Seabrook Station
License Amendment Request 01-12
“Changes to Spent Fuel Assembly Storage Technical Specification 3/4.9.13”

SEABROOK STATION UNIT 1

**License Amendment Request 01-12,
"Changes to Spent Fuel Assembly Storage Technical Specification 3/4.9.13"**

**Figure 3.9-1
Fuel Assembly Burnup vs. Initial Enrichment
For Spent Fuel Assemblies in BORAL® Storage**

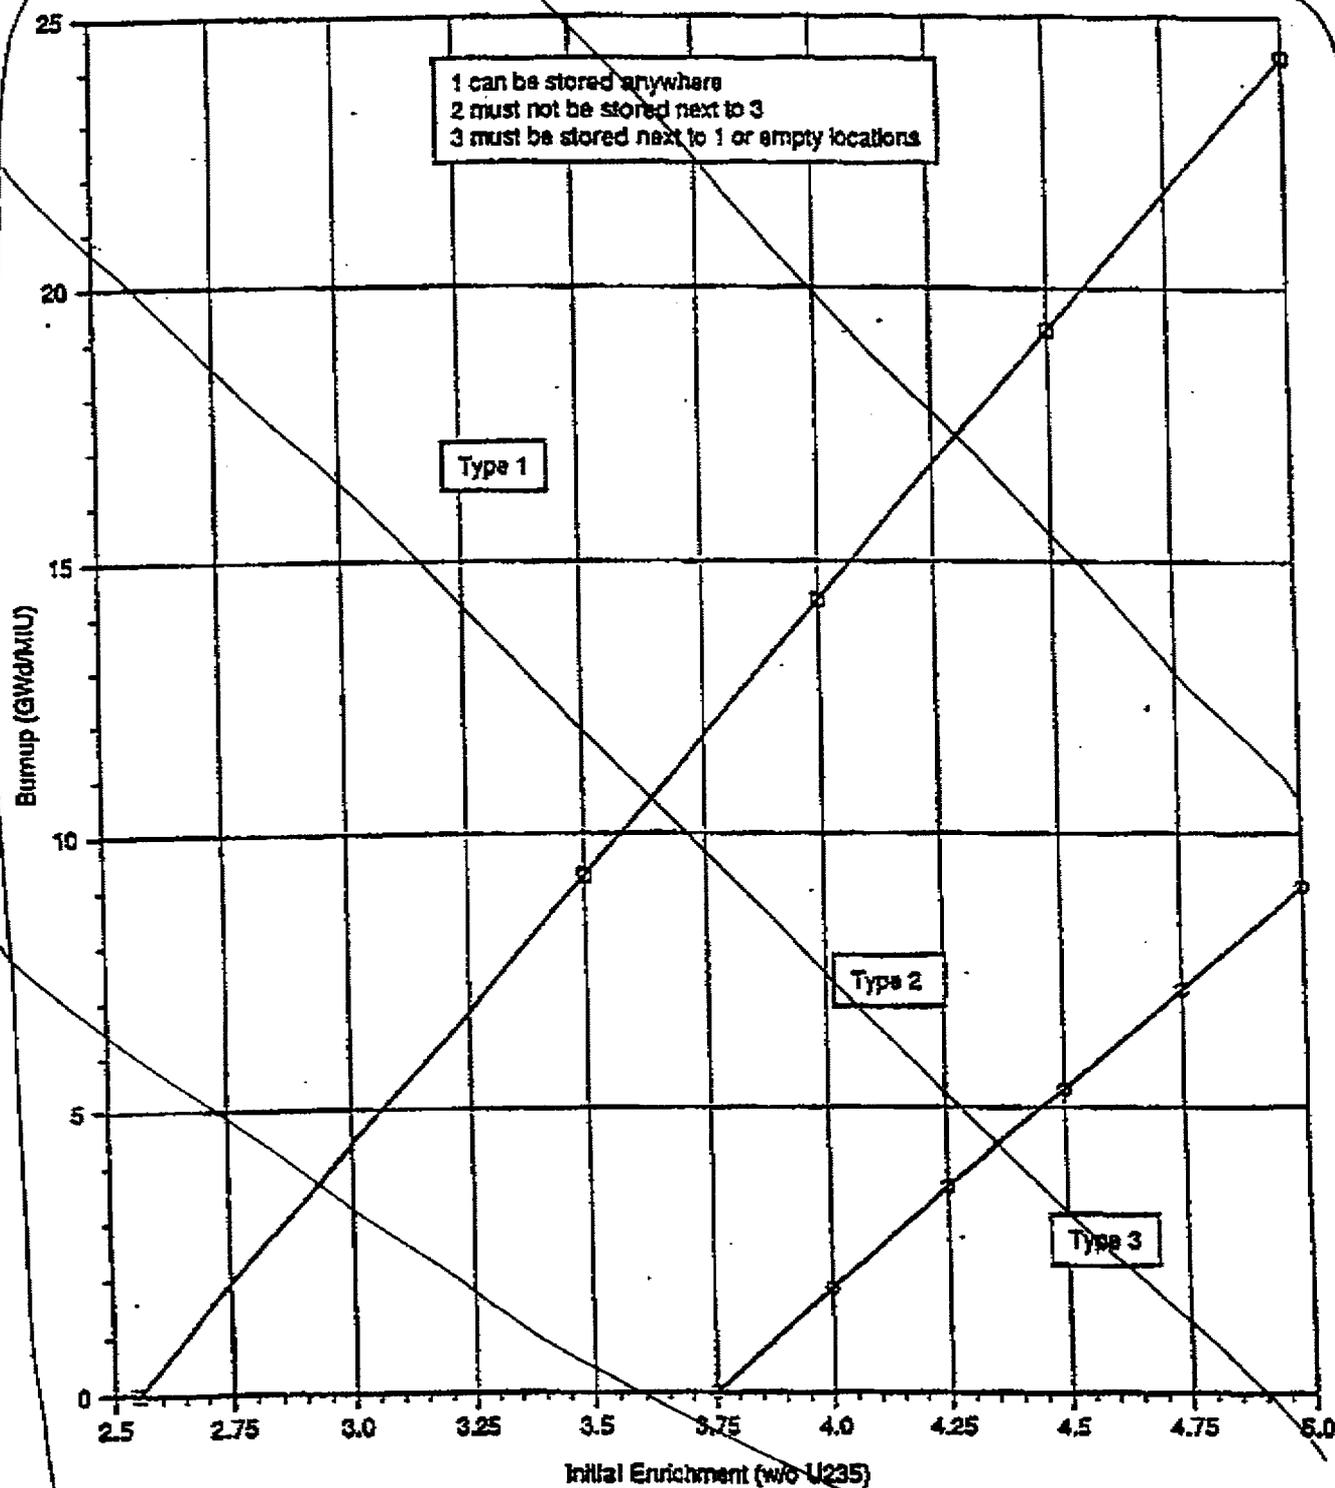
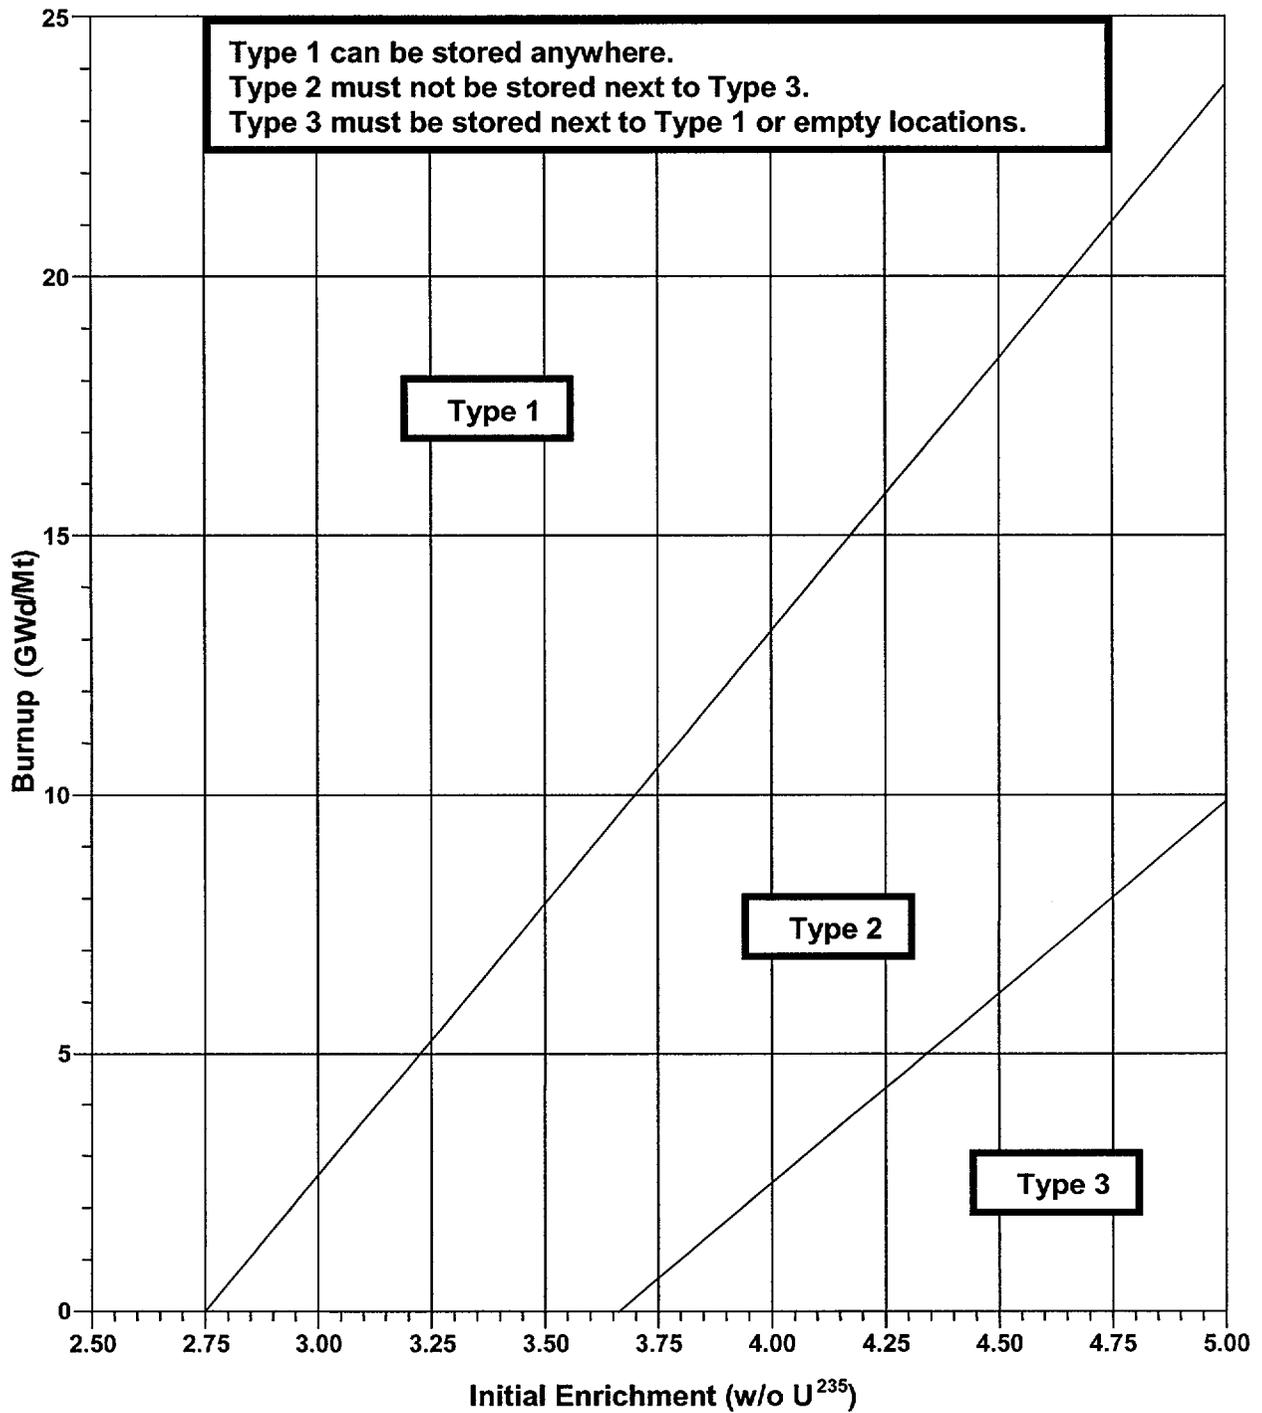
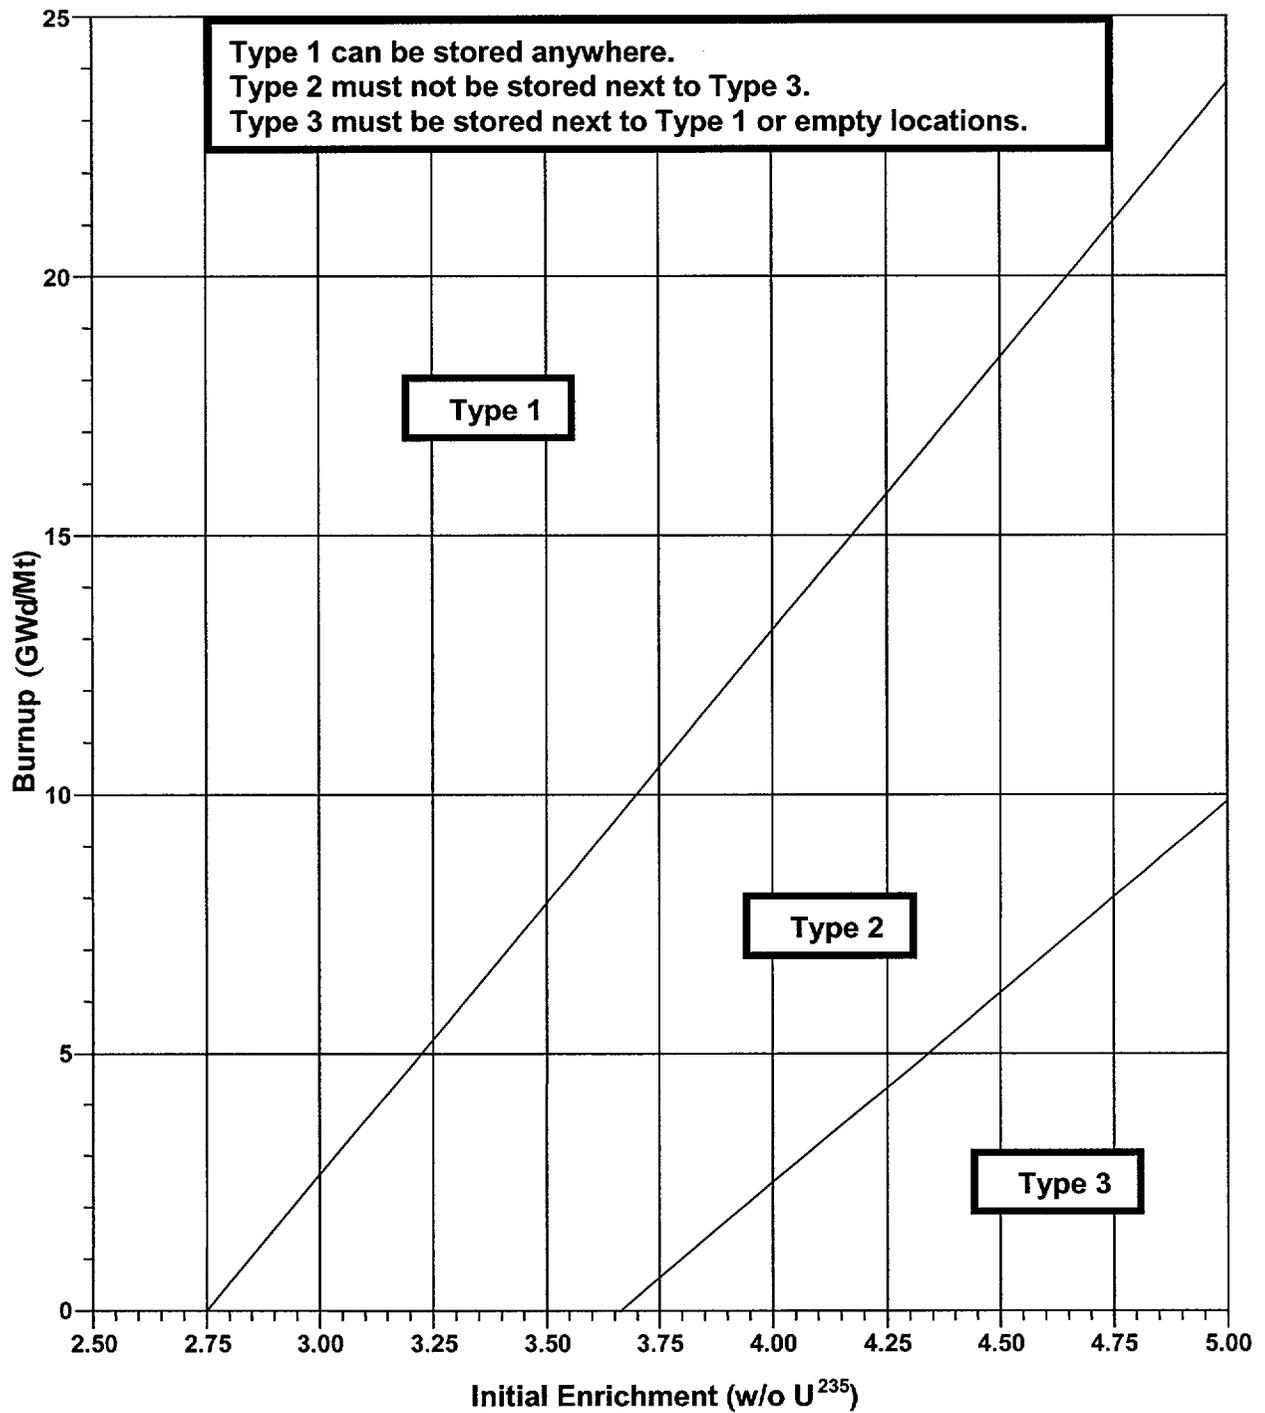
The results of the above analyses were used to develop the proposed Technical Specification loading curves (i.e., proposed TS Figures 3.9-1 and 3.9-2 for the BORAL[®] and BORAFLEX[®] Zones, respectively).

Replace with new Figures 3.9-1 (on pg 3/4 9-17) and 3.9-2 (on new pg 3/4 9-17A)
